**Sign Variance Report  
171 Dundas Street West**

<b>Date:</b>	December 3, 2007
<b>To:</b>	Toronto and East York Community Council
<b>From:</b>	Director, Community Planning, Toronto and East York District
<b>Wards:</b>	Ward 27 – Toronto Centre-Rosedale
<b>Reference Number:</b>	07-279152

# Attachment 1: Elevation

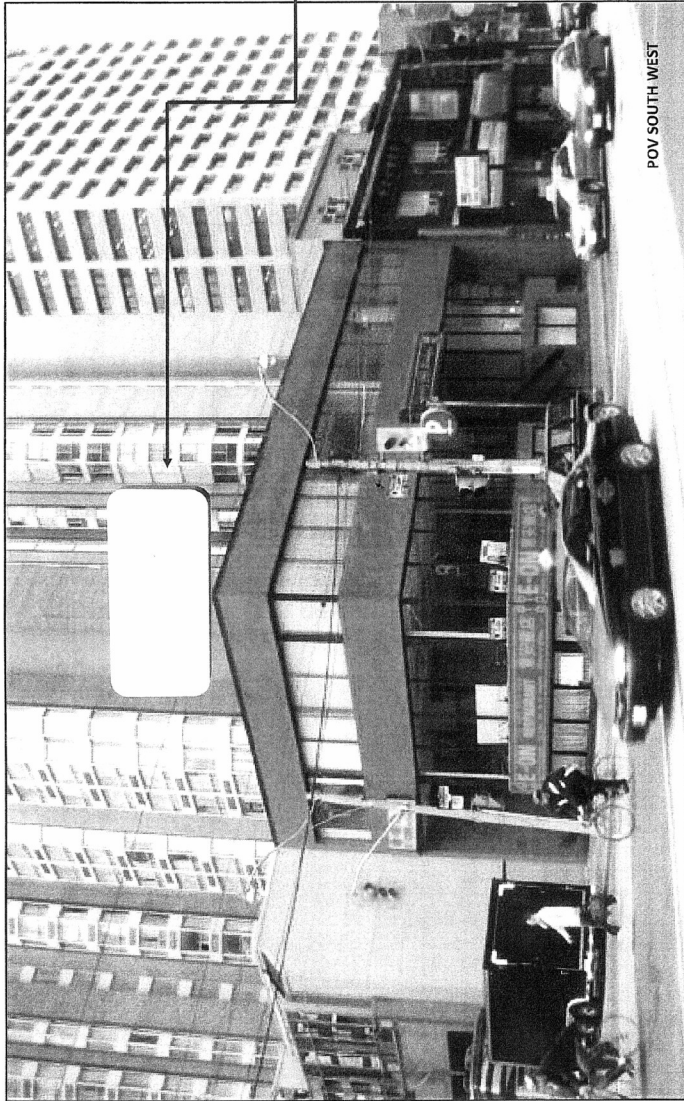
Staff recommends refusal of this application. The variance is major and not within the general intent and purpose of the Municipal Code.

<b>Sign By-law Section and Requirements</b>	<b>Applicant's Proposal</b>	<b>Required Variance</b>
1. Chapter 297-10D (16)	To erect, for third party advertising purposes, an illuminated tri-vision roof sign on top of a two-storey commercial building located in a CR zone.	A third party roof sign on a building located in a CR or MCR zone is not permitted.

At its meeting of April 24, 1995, City Council passed By-law 1995-0229 to amend Chapter 297 of the Municipal Code to prohibit roof signs in all CR and MCR zone districts in the former City of Toronto. The prohibition resulted from a study of signage along the City's "Main Streets" which detailed the unattractive appearance of roof signs within the mixed-use zone districts and from adjacent residential districts as well as the negative effect on skyline views. It is staff's opinion that the proposed sign would undermine the policy and diminish the objectives for quality urban design in this area.

1. Toronto and East York Community Council refuse the request for a

variance to permit, for third party advertising purposes, an illuminated roof sign on a two storey commercial building at 171 Dundas Street West.
